Network PTZ Dome Camera Firmware

Version: V5.5.6 Release Note

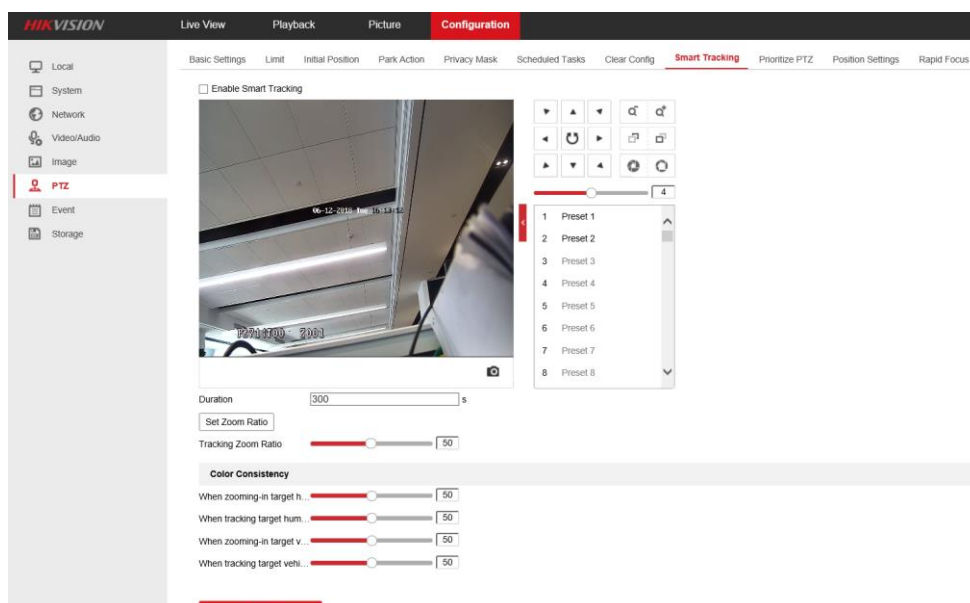
- 1) Supports all released DF series PTZ Camera(including DS-2DF8xxxx, DS-2DF6Axxxx, DS-2DF7xxxx, DS-2DF5xxxx), please refer to ***Supported Model List***
- 2) Both DS-2DF8xxxx and DS-2DF6Axxx models support Rapid Focus function; Rapid Focus function effect in the night mode was optimized
- 3) Optimize Smart Tracking effect and add color Consistency parameters

Tracking Zoom Ratio:

Adjust the Tracking Zoom Ratio to a desired value. Then the camera determines the actual zoom ratio dynamically according to the detected target size and the set value. Larger value means larger zoom ratio.

Color Consistency:

The camera checks the color of the detected target several times during tracking and compares the color resemblance to determine whether it should continue to track the target or not. If the returned resemblance is lower than the set value, the camera stops tracking.

You can set the resemblance thresholds for different targets at different tracking stages. Higher value means higher resemblance requirement to continue tracking.
